PRINTWORKS

STUDENT ACCOMMODATION SCHEME

PRINT-1000-ZZ-ZZ-RP-0002

NMA 2: DESIGN AND ACCESS STATEMENT ADDENDUM

FIGURE 22. Proposed Scheme - Printworks L05

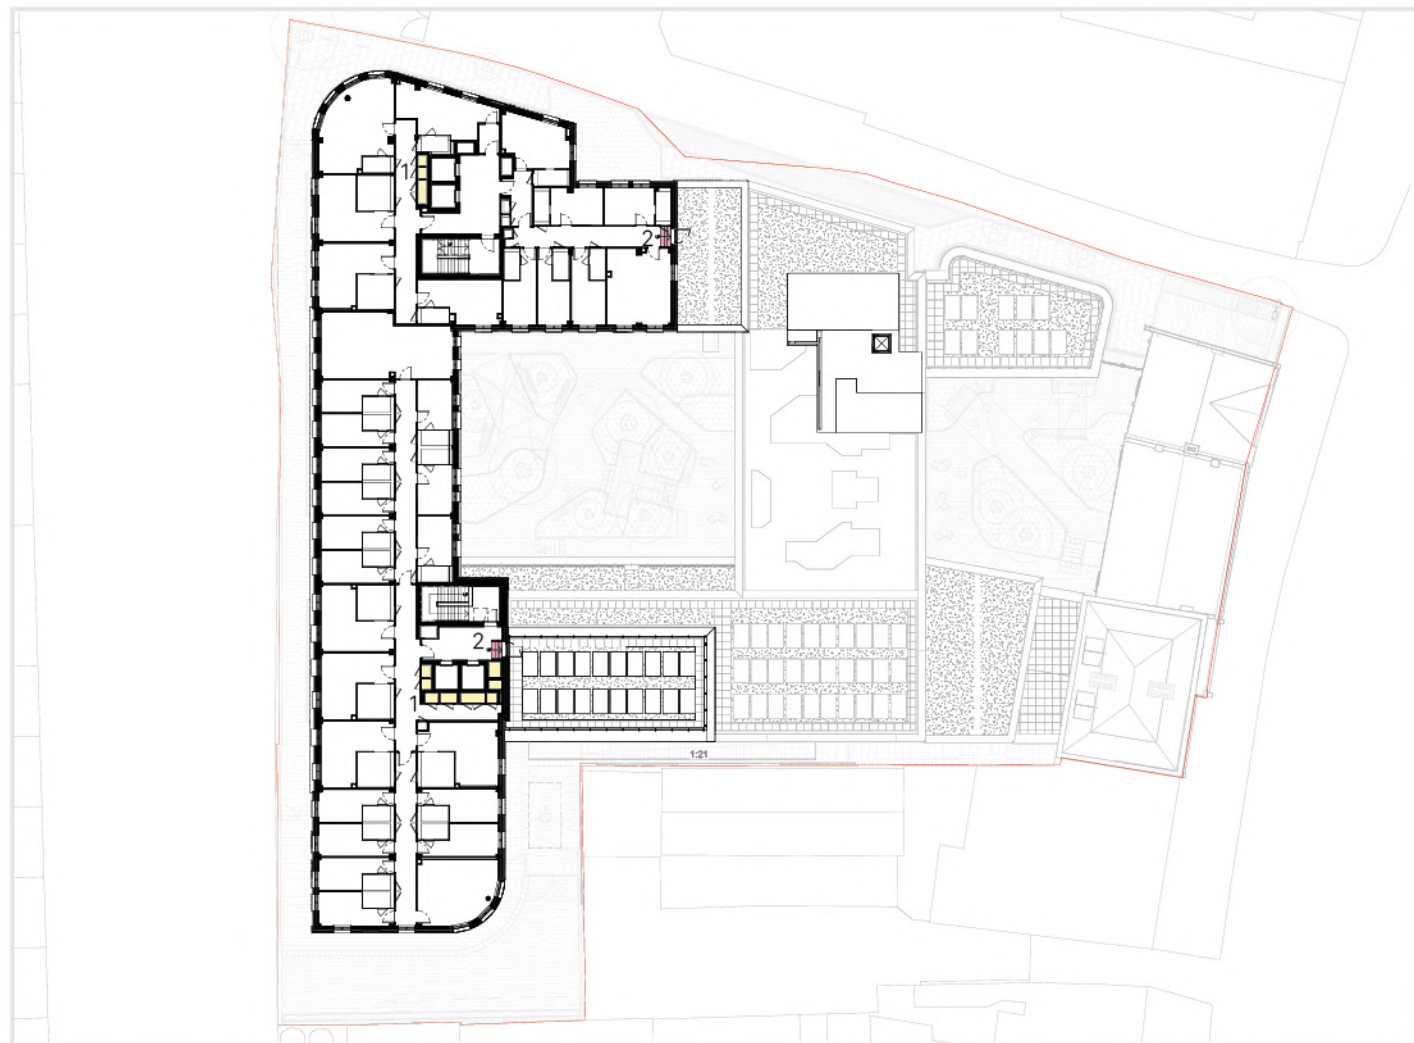
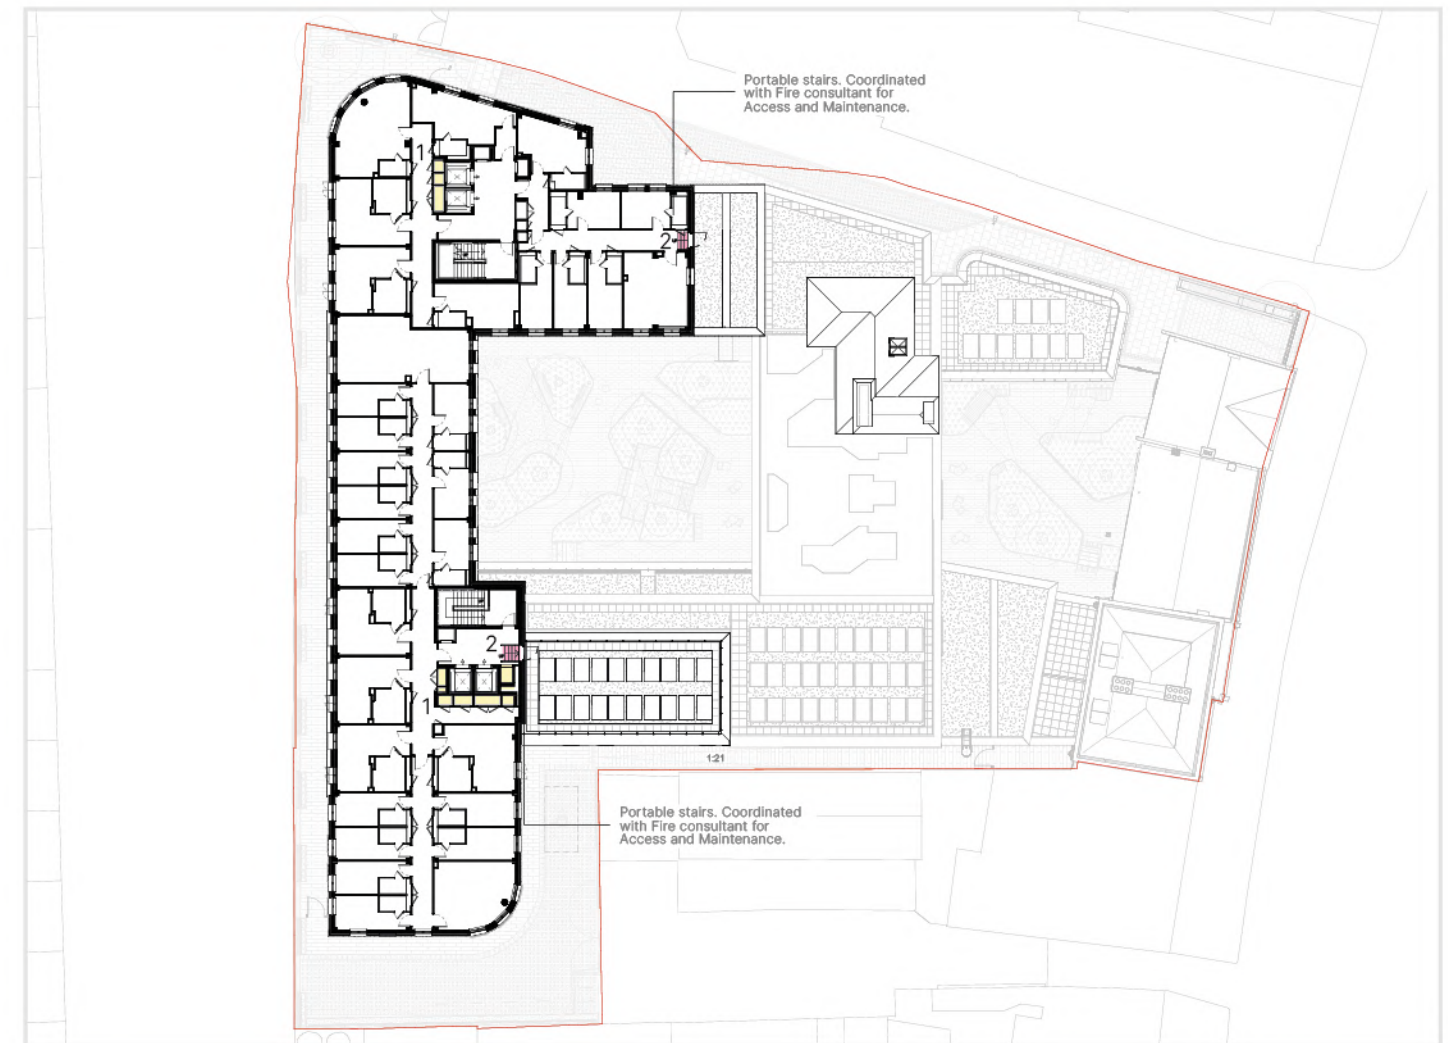
- Adjustments to riser internal separating partitions in cores as response to MEP engineer requirements. Minor adjustments to roof maintenance access internal stairs due to design development of interior layout and concrete upstands.

FIGURE 24. Proposed Scheme - Printworks L06

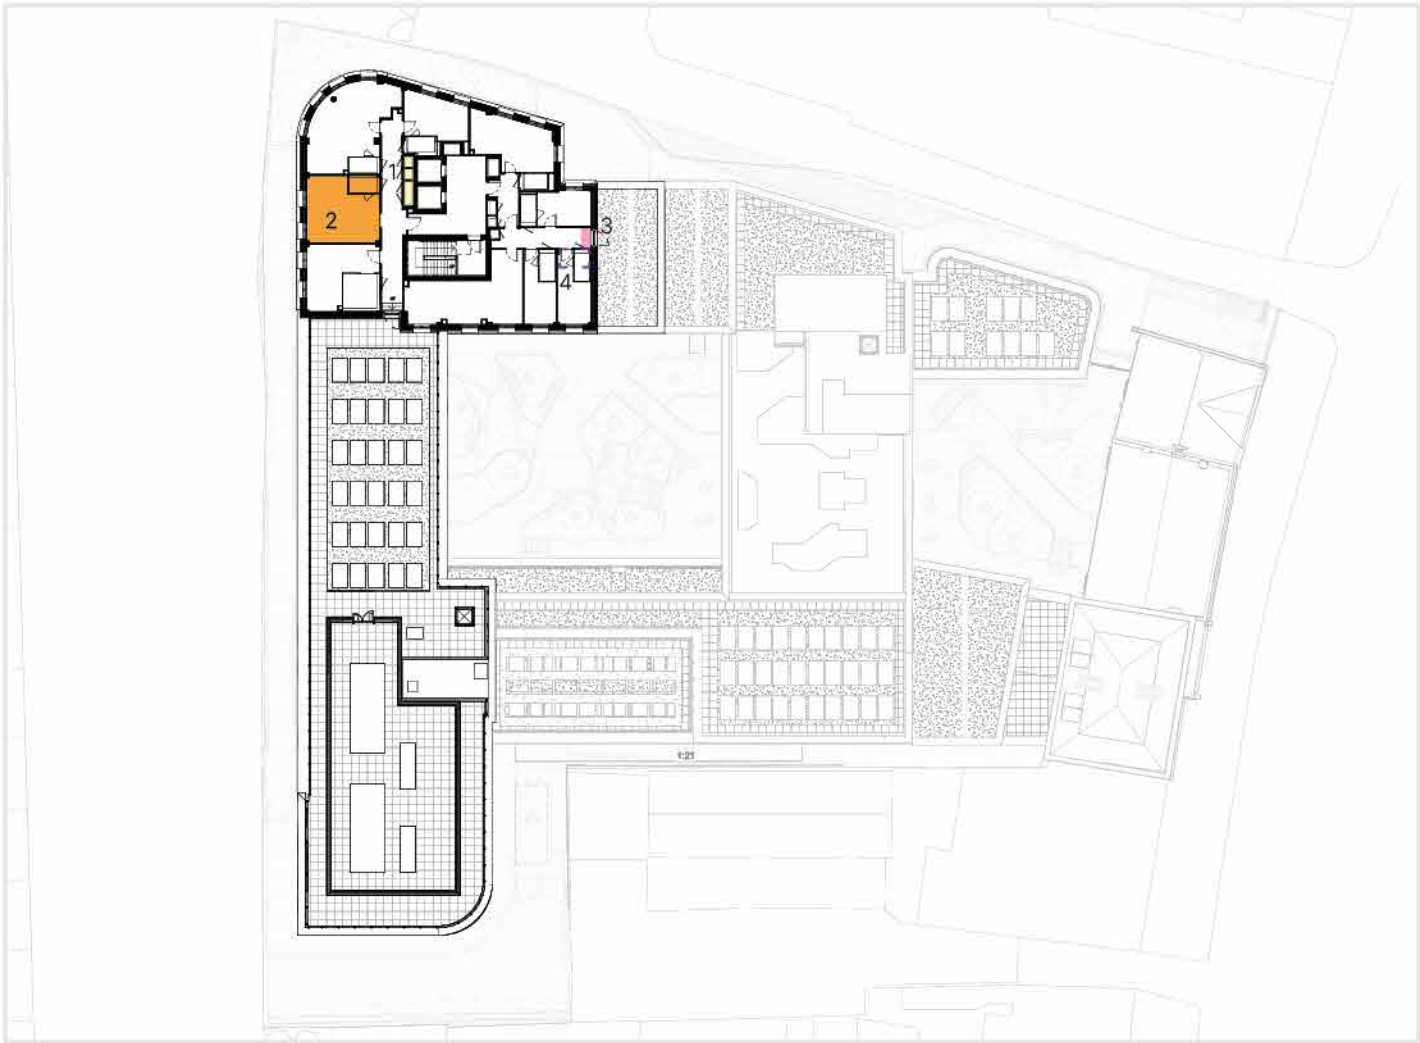
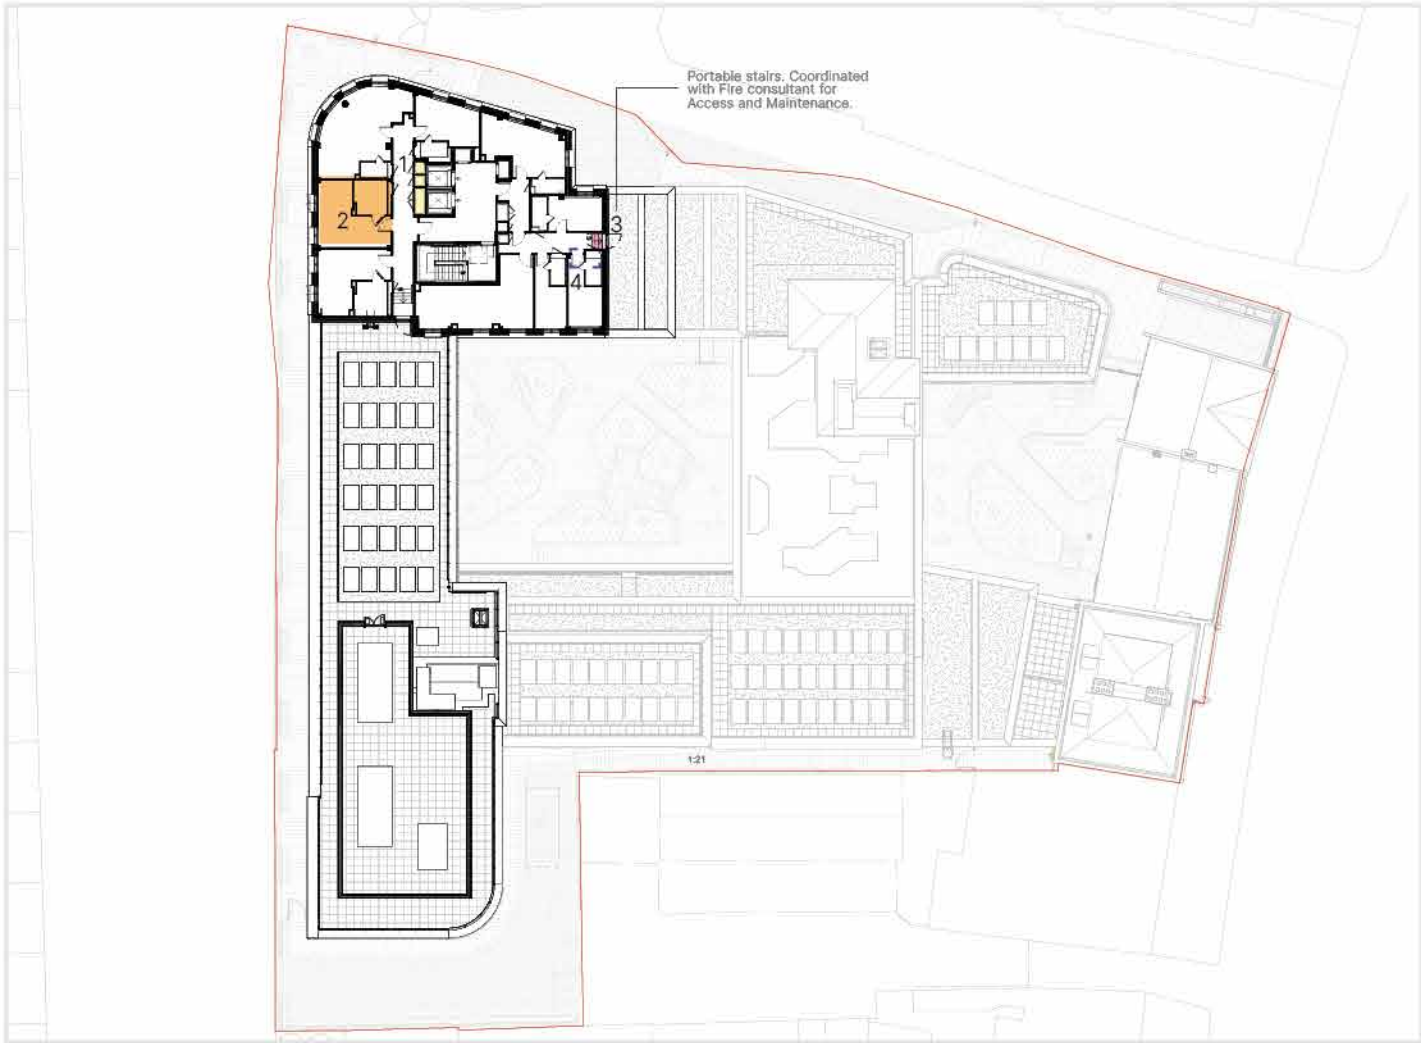
- 1. Adjustments to riser internal separating partitions in cores as response to MEP engineer requirements.
- 2. Minor layout amendments arising from ongoing design development in response to PBSA operator input and interior design coordination. Update from Studio Premium to Accessible Studio. The bedroom layout has been updated with only minimal amendments, principally to increase the number of accessible bedrooms so the scheme meets the requirements of Condition 5.
- 3. Minor adjustments to roof maintenance access stairs due to design development of interior layout and concrete upstands.
- 4. Small amendments to the highlighted partition following EDC and Walsh input and advice.

FIGURE 26. Proposed Scheme - Printworks Roof Plan

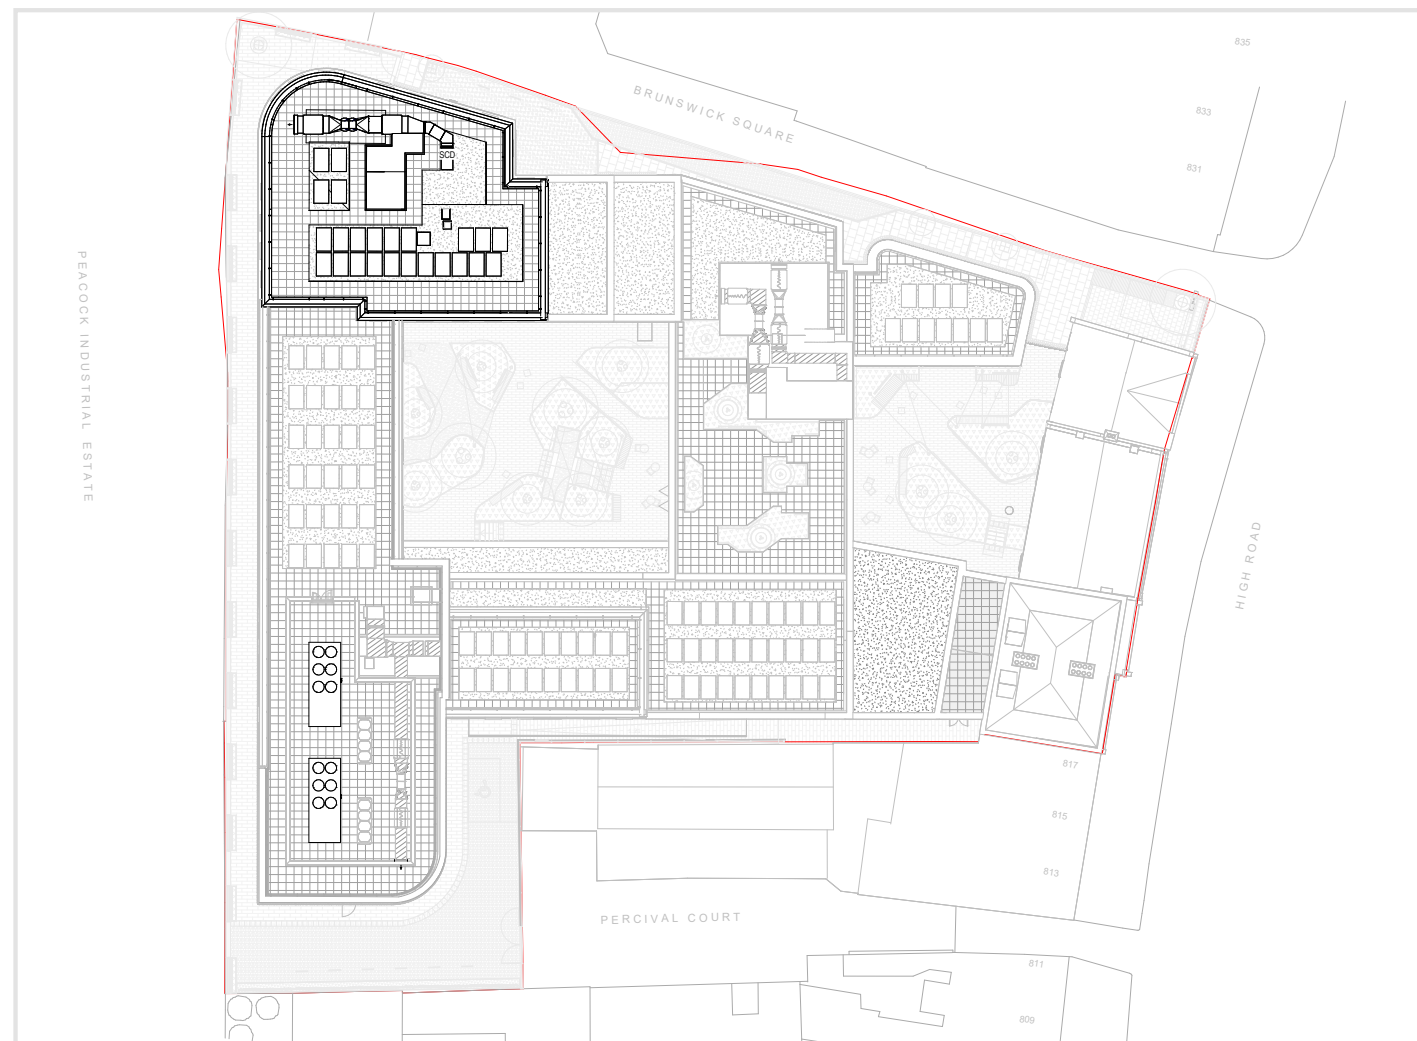
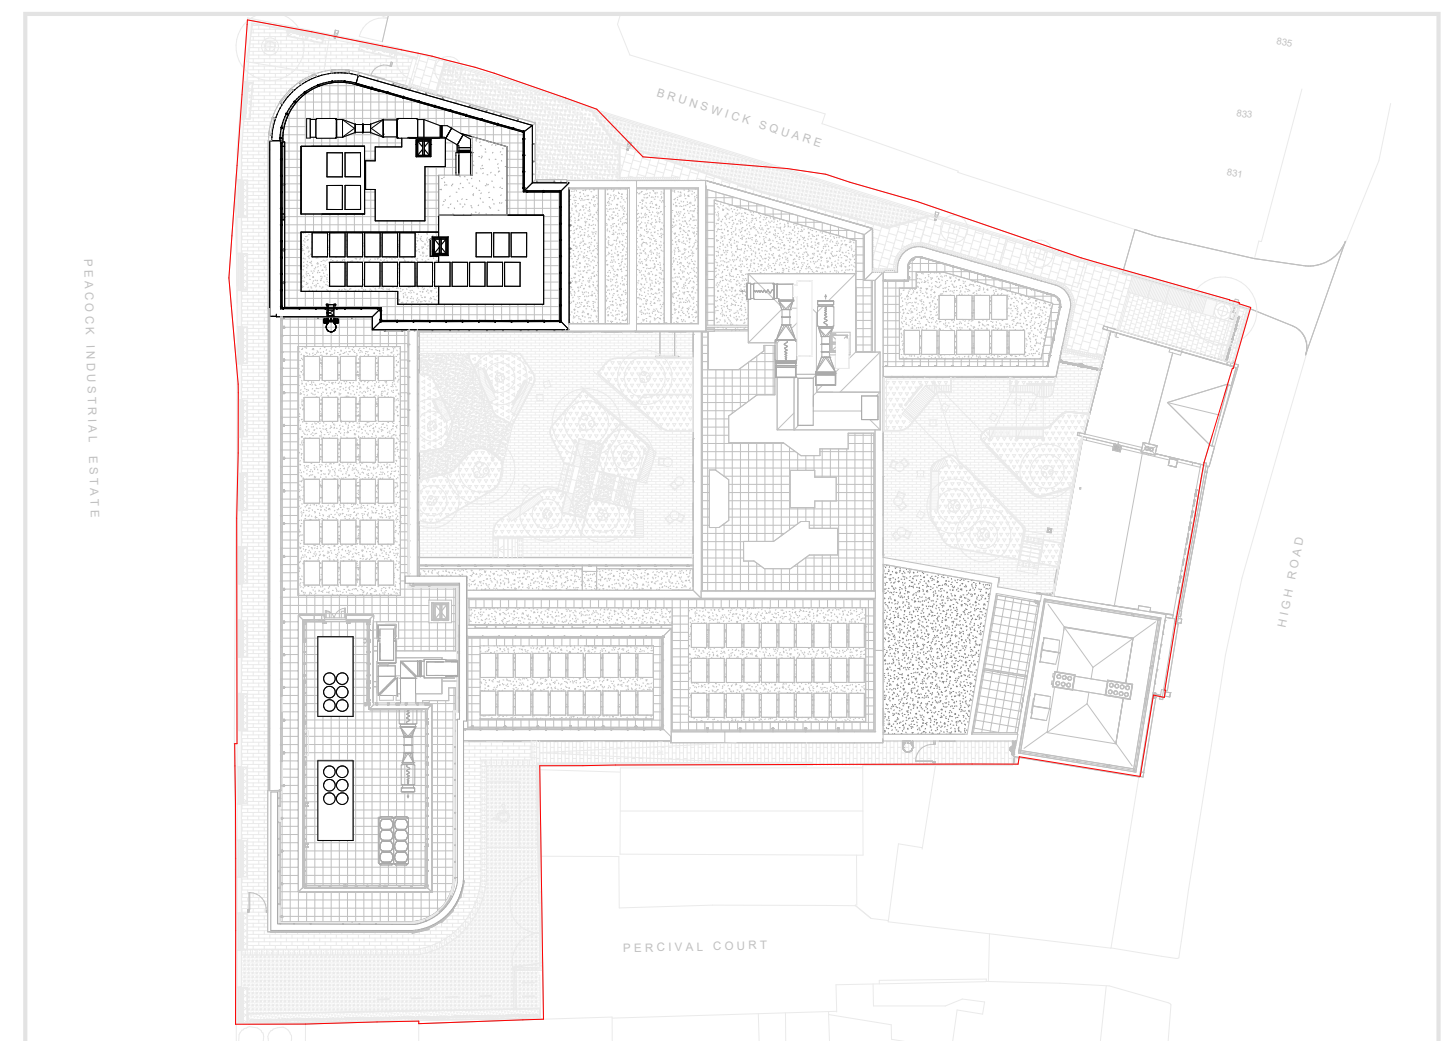
- Roof construction details and MEP Plant developed with specialist input. No overall changes to height. In accordance with submitted and approved energy and overheating strategy.
- Note: Roofs and landscape layouts covered by separate drawings and Discharge of Condition documents. Final layouts and MEP equipment subject to development based on specialist's input.

FIGURE 28. Proposed Scheme - Printworks L02

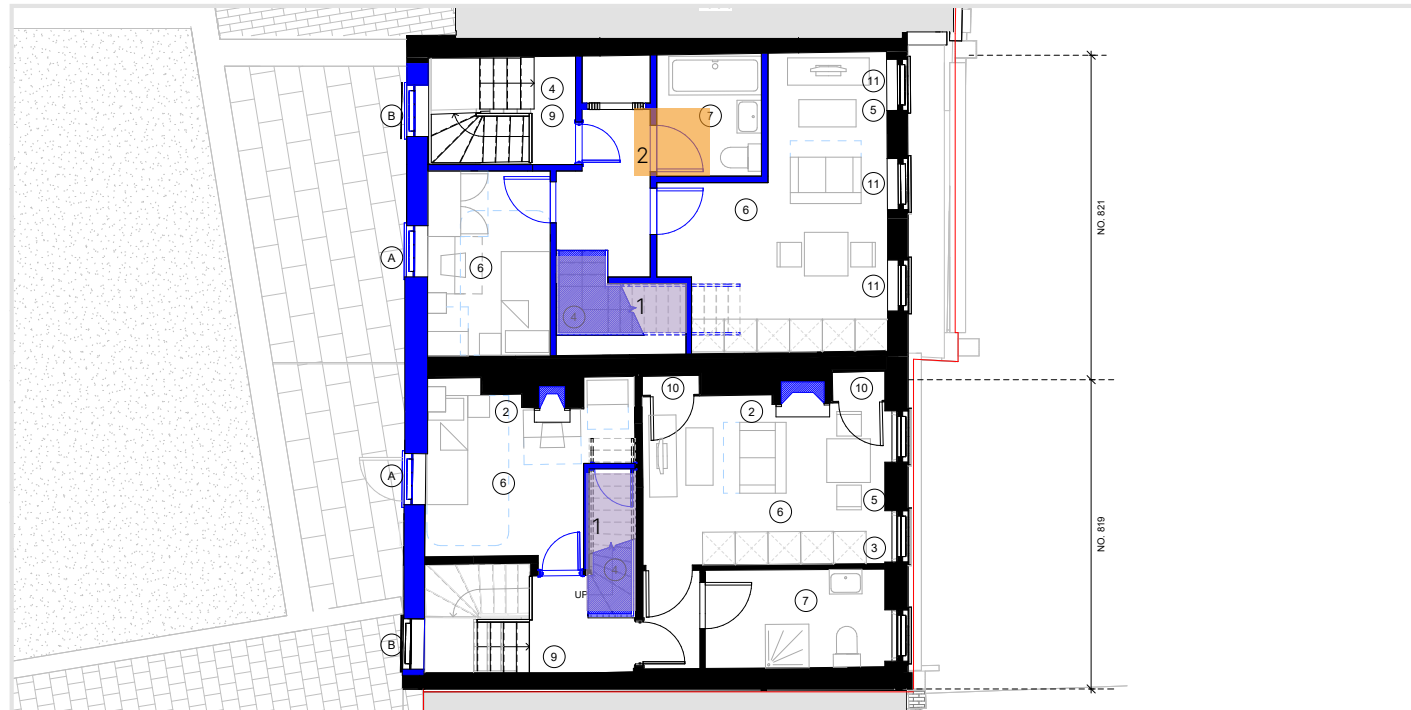
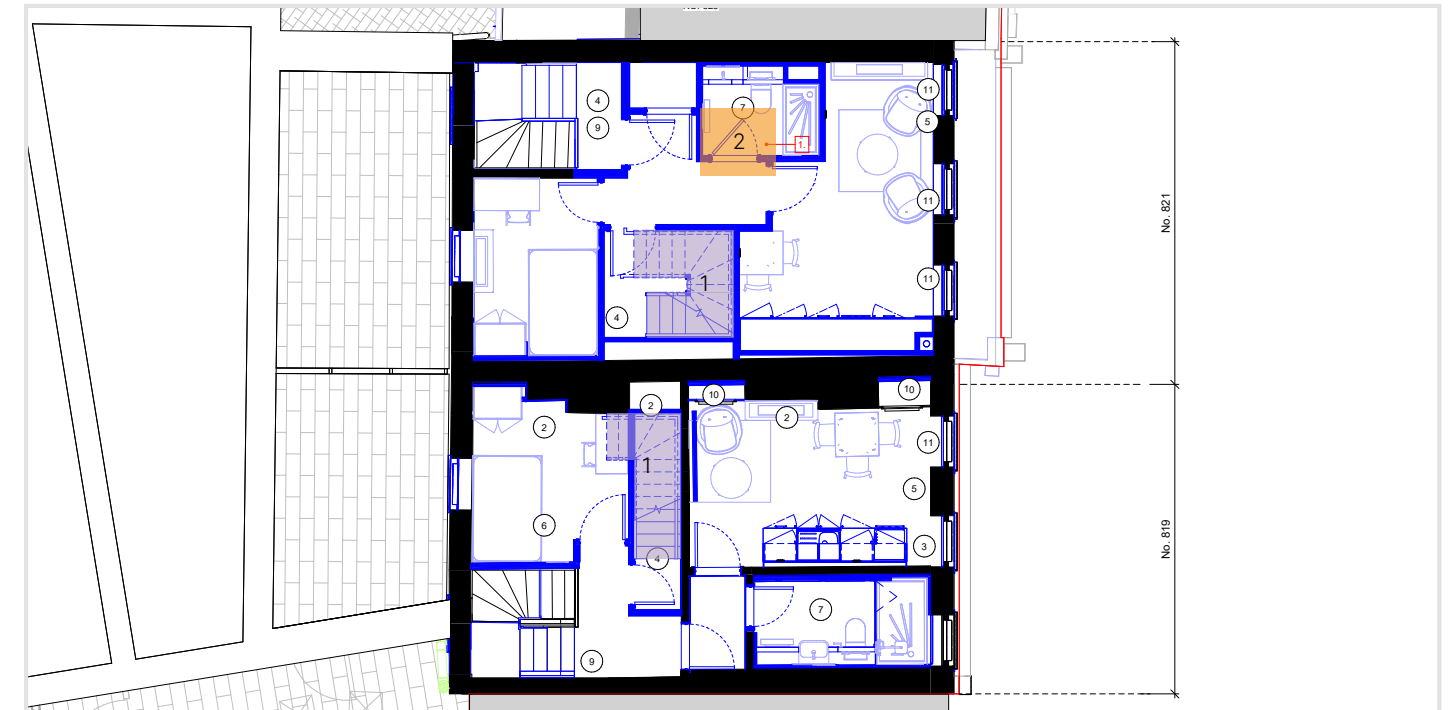
1. Staircase arrangement altered.
2. Ensuited to L03 rooms relocated.
